Descriptive Report to Accompany Hydrographic Survey H12086

Project OPR-P357-RA-FA-09
Southern Portion of Cook Inlet, Alaska
Tutka Bay
Scale 1:10,000
September 2009
NOAA Ship *Rainier* (s221)
Chief of Party: Captain Donald W. Haines, NOAA

Revisions and Corrections Compiled During Office Processing and Certification

Figure 2: Sounding Density; Red less than 5, Blue being more than 5

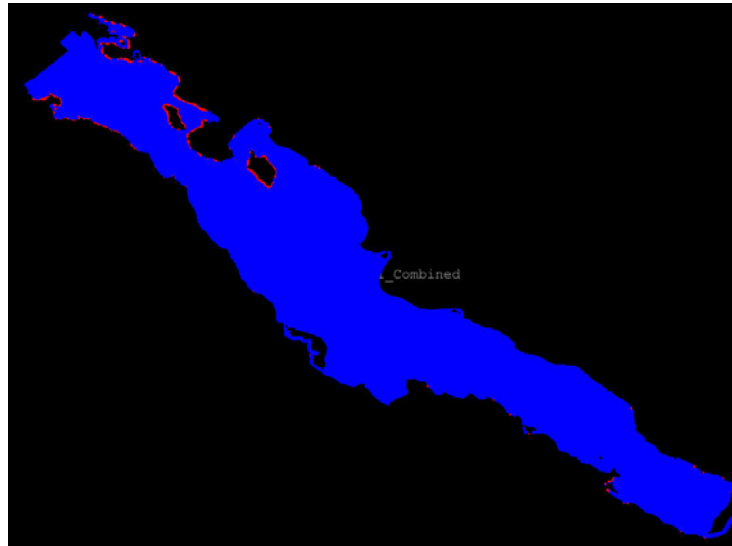
Uncertainty values of submitted, finalized grids are calculated in CARIS using the “Greater of the Two” of total propagated uncertainty and standard deviation (scaled to 95%). An IHO_1 “child” attribute layer was created for the H12086_Final_Combined surface in CARIS HIPS for analysis. Throughout the majority of the survey, uncertainty values for H12086 fall below the IHO levels as described in the NOS Specifications and Deliverables. The exception to these results occurred along very near-shore areas when using the tilted Reson 8125 sonar

³ No soundings from red areas were selected for charting. There was nothing navigationally significant in the “red” areas.

Figure 3: Junction between H12086 and H12087

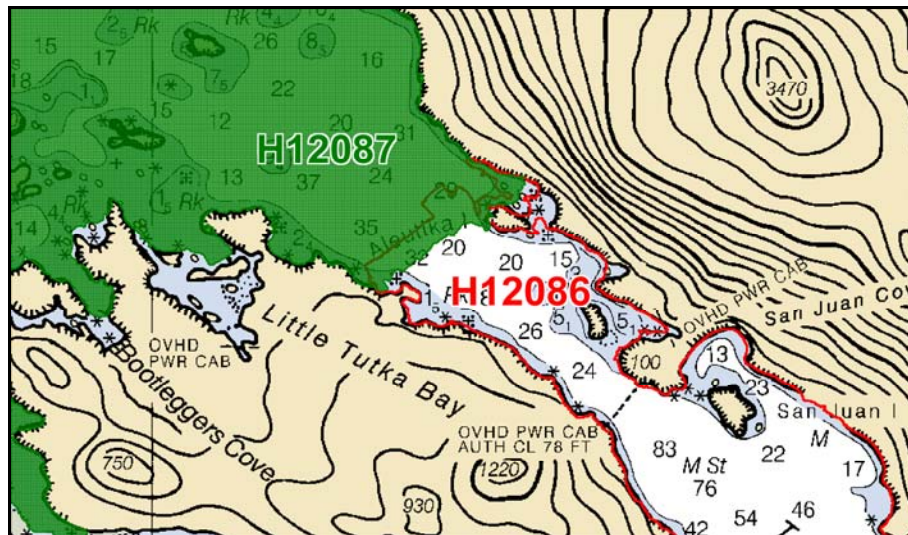
Survey H12086 junctions with H12087, which is Sheet D of the same project.⁴ The area of overlap between the sheets was reviewed in CARIS Subset Editor for consistency and data were found to be in good general agreement within 0.5m on steep slopes and 0.2 meters in the deep (40-60m) waters mid-channel. The sheet limits and area of overlap for sheets H12086 and H12087 are shown in Figure 3. Table 3 lists all H12086 junction surveys.

⁴ A common junction will be made with H12087 to the NW during compilation process.

Figure 4: A near shore holiday located near Aleutika Island

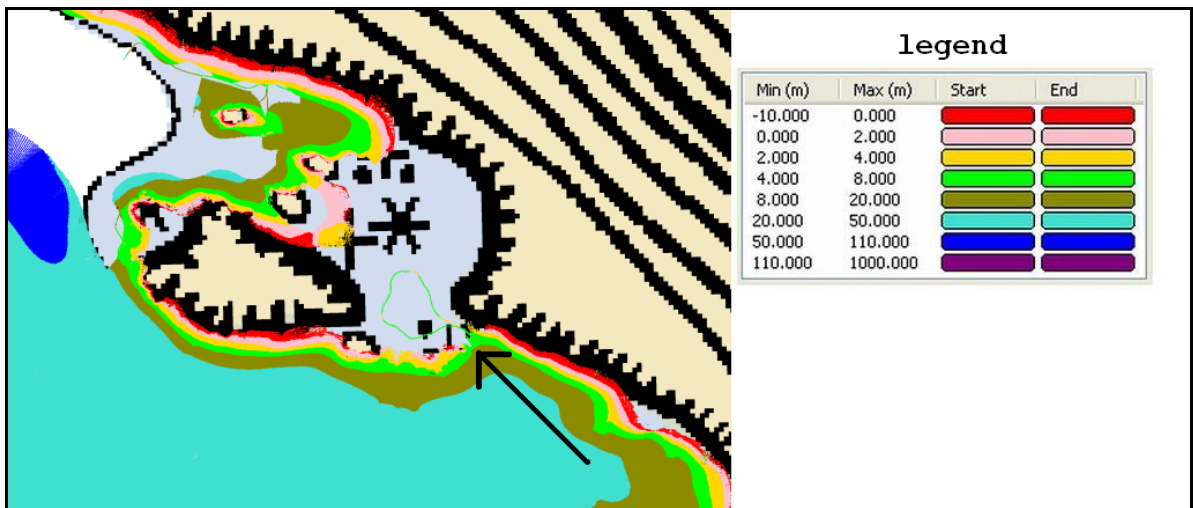
There are two areas where the 4m curve was not defined; the mouth of the small inlet behind Aleutika Island (Figure 4), and a small section of the northern shore of Tutka Bay around 2.3 nm from the head of the bay (Figure 5).⁶

⁶ Concur. The holiday has been preserved in the HCell and proper modifications were made to the area.

Figure 11: A 14 fathom charted depth in 18 fathoms of water

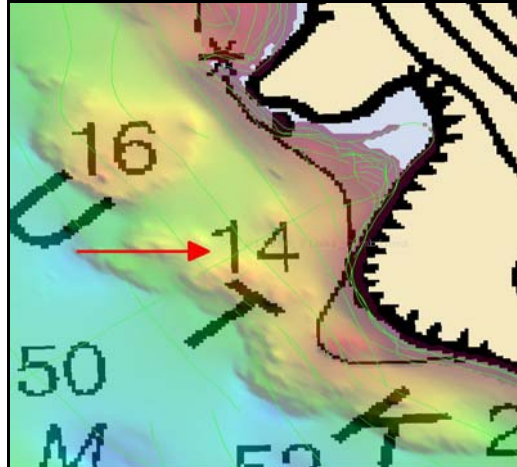
- Survey soundings show a minimum depth of 17-fathom in the area of a 14-fathom charted depth, with a 16-fathom shoal located immediately to the south (figure 11).¹⁰

¹⁰ Concur with clarification. A 14 fathom sounding was added to the HCell representing the shoalest point in that area.

Figure 12: A 32 fathom charted depth on a 19½ fathom shoal

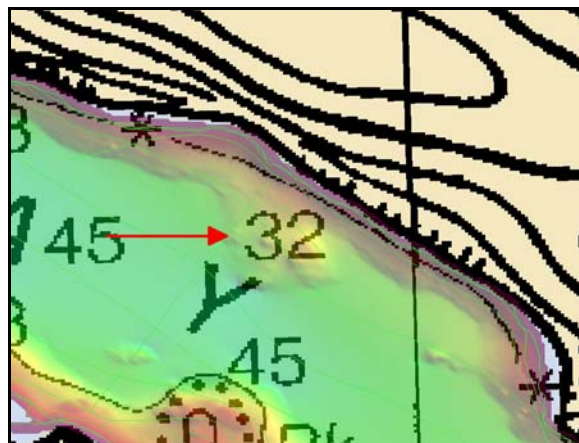
- Survey soundings show a depth of 19½-fathom shoal in the vicinity of a 32-fathom charted depth (figure 12).¹¹

¹¹ Concur. Chart depths as depicted in the HCell.

Figure 13: Location of overhead features

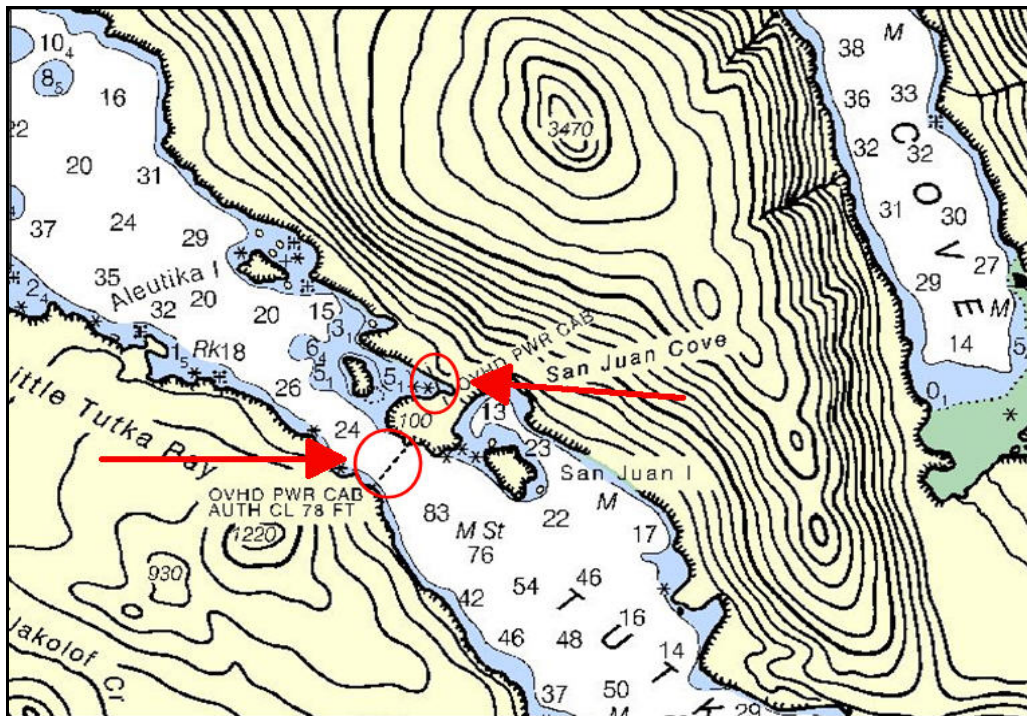
H12086 contains one overhead feature, a power-line that crosses Tutka Bay in two different locations (figure 13). This power-line is charted in the correct location and the Coast Pilot reported height of 78 feet above mean high water (MHW) appeared to be appropriate, although no direct measurement was conducted in the field.¹⁹

¹⁹ Concur. The overhead features have been blue noted to be retained.
